## Submissions Report

New High School for Medowie  
6 Abundance Road, Medowie

Submitted to the NSW Department of Education  
on behalf of Gyde Consulting

15 May 2025

Figure 2.1 Modified proposal for bus stops, kiss and ride space, kerbside parking and footpaths

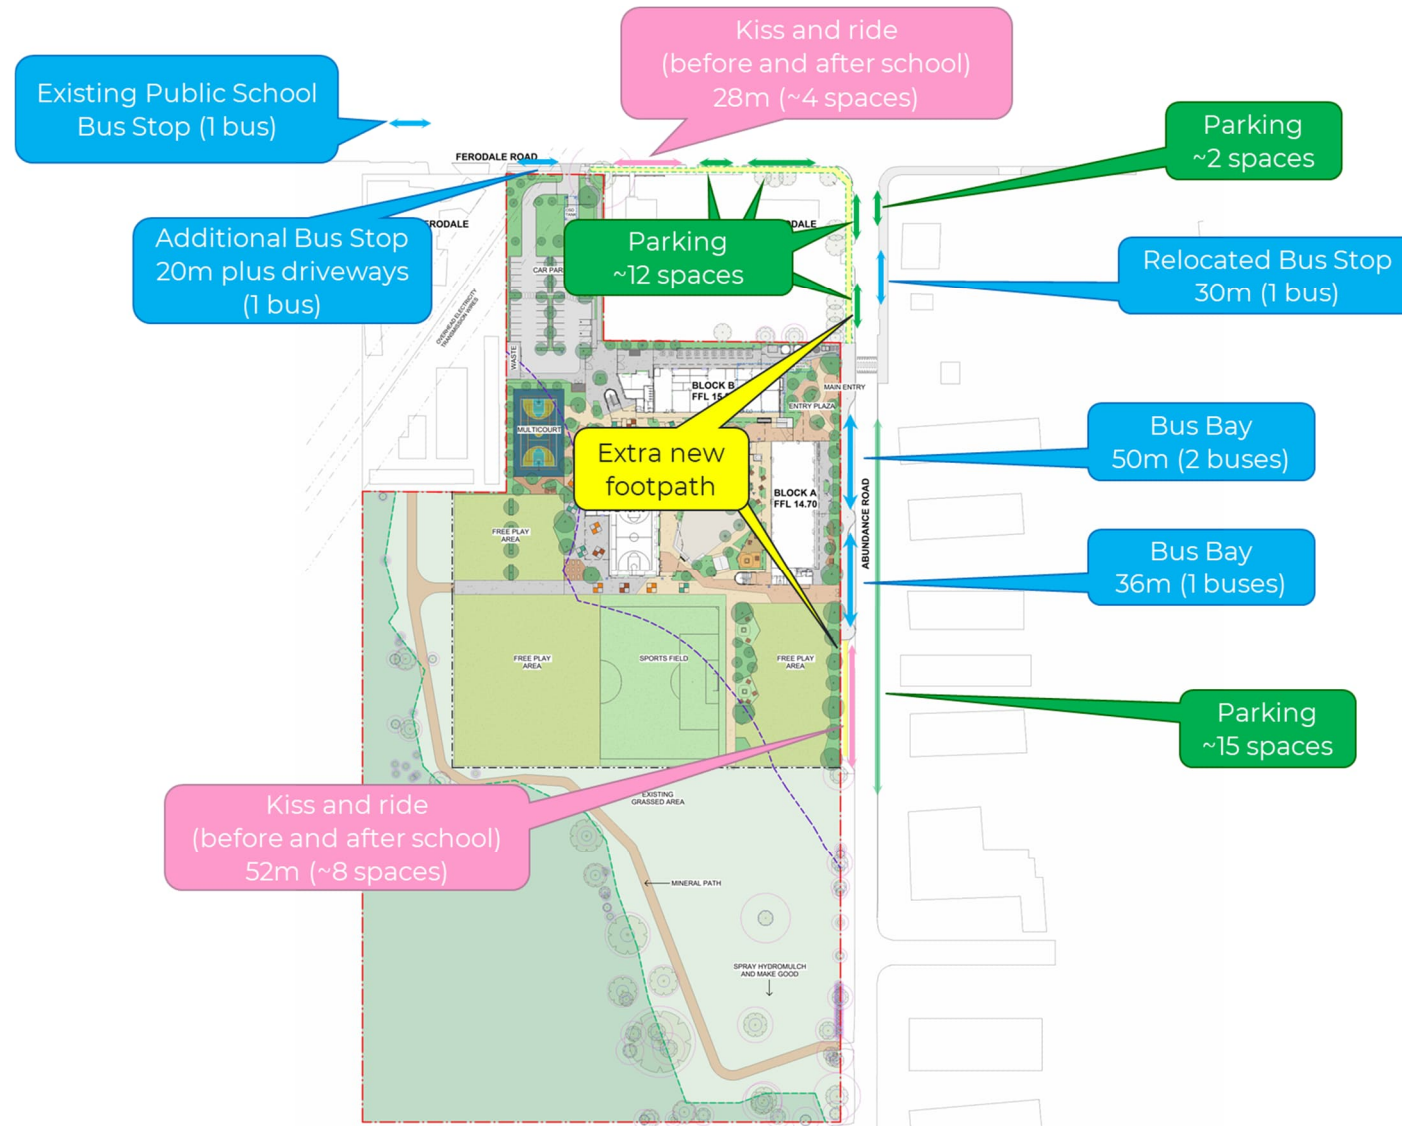
Drop off and pick up zones	Concerns regarding the drop off / pick up system and its creation of further congestion in the area as it is not long enough.	<p>The public domain plans have been updated to reflect the additional kiss and ride drop off zones being provided. The original location on Abundance Road has been moved further south and has increased from 36 metres to 52 metres which can now accommodate eight cars. In addition, a new 28 metre kiss and ride drop off zone has been provided on Ferodale Road which can accommodate four cars. In total the kiss and ride drop off zone capacity has increased from five to twelve, which will ensure no congestion occurs.</p> <p>Ongoing monitoring of the kiss and ride drop off zone will be required by the Travel Plan Coordinator in conjunction with the department once school travel patterns are better understood (addressed under Mitigation Measure TR5 outlined in the REF).</p>

Topic	Comment	Response
		to the school operation, and constructed to Council's requirements.
	<p>A U-Turn in some form should be provided along Abundance Road to access the drop off / pick up zone safely for both cars and buses.</p> <p>Council requested a roundabout at the Industrial Road and Abundance Road intersection to prevent illegal U-Turns from occurring.</p>	<p>The potential for U-Turns has been mitigated by the provision of the additional kiss and ride drop off zones onto Ferodale Road. This will allow parents flexibility to use either kiss and ride drop off zone and not be required to travel south onto Abundance Road if they so choose. Additional Mitigation Measures have been provided in <b>Table 4</b> and <b>Appendix 1</b> to the REF to ensure that illegal U-Turns do not occur.</p>
Footpaths and pedestrian crossings	<p>The pedestrian crossing on Ferodale Road warrants further consideration and may be too narrow for the increased foot traffic.</p> <p>Council requests the upgrade of the existing pedestrian refuge located adjacent to the Medowie Ambulance Station to a formalised crossing.</p>	<p>The traffic engineers assessed the trip generation based on estimated hourly traffic volumes and projected pedestrian activity, which is confirmed as not likely to meet the criteria for a zebra crossing at this location once the school becomes operational.</p> <p>It is recommended that following the school opening, a formal warrant assessment including traffic and pedestrian counts be conducted to support and justify this upgrade. A Mitigation Measure has been added in <b>Table 4</b> and <b>Appendix 1</b> of the REF.</p>

Based on the feedback received from agencies and the public, a modified proposal is shown in Figure 2.1 overleaf. Changes include the addition of new footpath on Abundance Road and Ferodale Road linking the two school entry gates, the relocation and addition of bus stops and the relocation and addition of kiss and ride space.

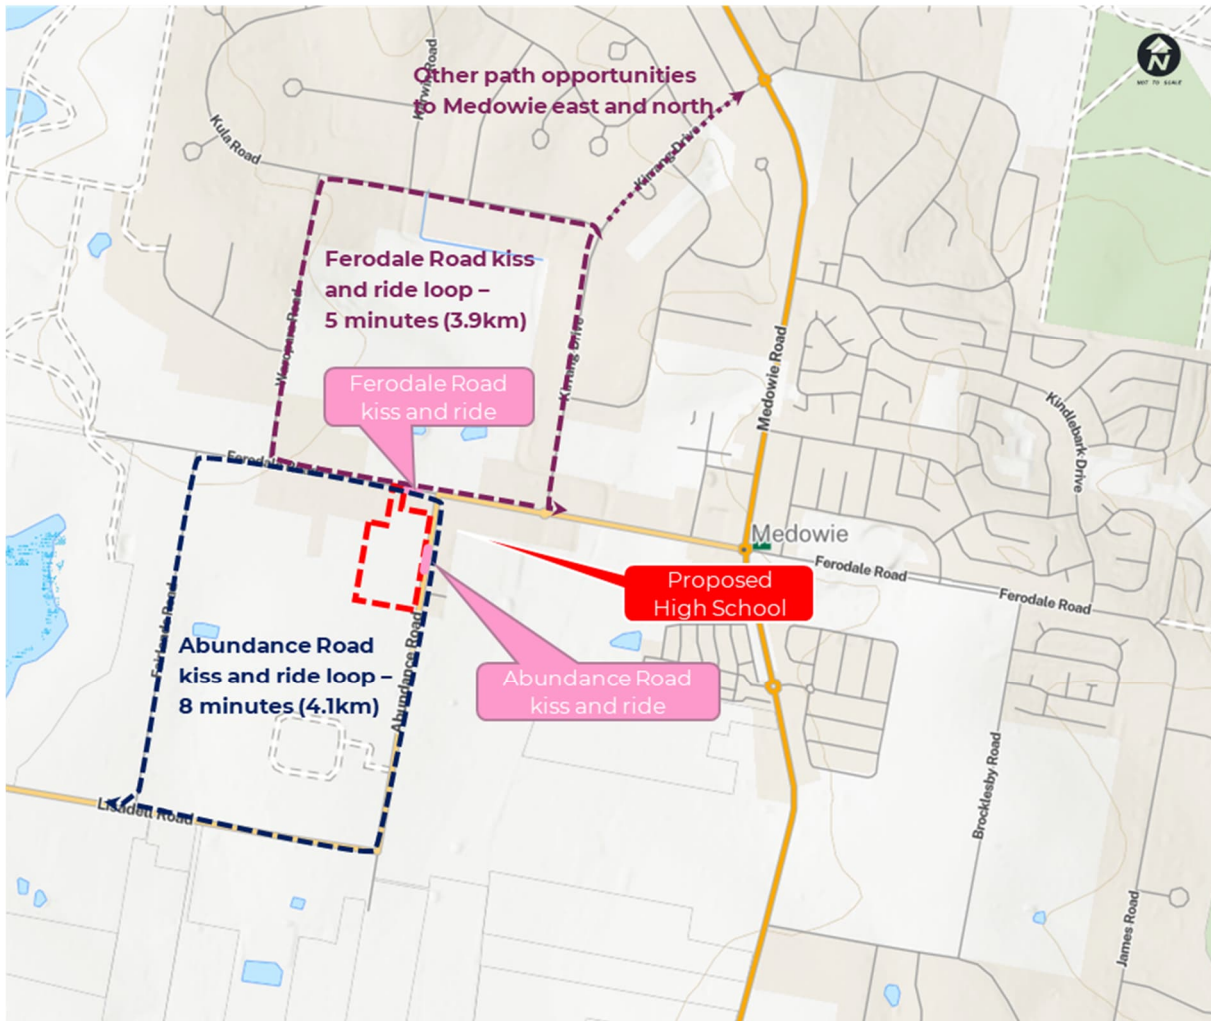
Topic	Comment	Response
Existing Abundance Road bus stop	TfNSW note that the existing bus stop ID 2318103 does not have infrastructure or a footpath to the proposed wombat crossing.	The existing bus stop is to be relocated north of the pedestrian crossing and will be connected to the crossing with the proposed footpath. The public domain plans in <b>Appendix 7</b> of the REF identify this new bus stop location and footpath connection.
Additional bus bay	TfNSW strongly recommend an additional bus bay to Ferodale Road.	Addressed above.
Conflict between bus and private car	Best practice is to provide separate bus bays and kiss and ride drop off zones.	The revised design proposes separate bus stops, separated by kerb extensions.
Transport documents	TfNSW note that the following documents are to be applied to the design: <ul style="list-style-type: none"> <li>• Design of Roads and Streets</li> <li>• Cycleway Design Toolbox</li> <li>• Walking Space Guide</li> </ul>	The traffic engineer confirms that these documents have been applied.

The proposed changes will provide additional bus stops, improved accessibility to bus stops and additional space for school buses to load passengers. The modified proposal includes:

- Bus stops in both directions on Abundance Road and Ferodale Road, providing flexibility for school bus services and regular passenger services.
- Bus stops with concrete pads that are connected to the new school by footpaths and marked pedestrian crossings, providing accessibility for people with reduced mobility.
- A main bus stop on Abundance Road, west side (northbound) with three bus spaces, allowing two school buses to load passengers, while preserving an active stop for regular passenger services
- A corresponding southbound stop on Abundance Road, relocated to north of the pedestrian crossing to give footpath accessibility
- A new westbound stop in front of the new school on Ferodale Road allowing a third school bus to load passengers.

These combination of bus stops provide sufficient capacity for the projected 15 school buses needed for the school with Transport for NSW's recommended five-minute dwell time within a 30 minute clearance period. The provision of space for active bus stops gives the flexibility for buses to pick up passengers on their way to/from other locations without being delayed waiting to get to a bus stop.
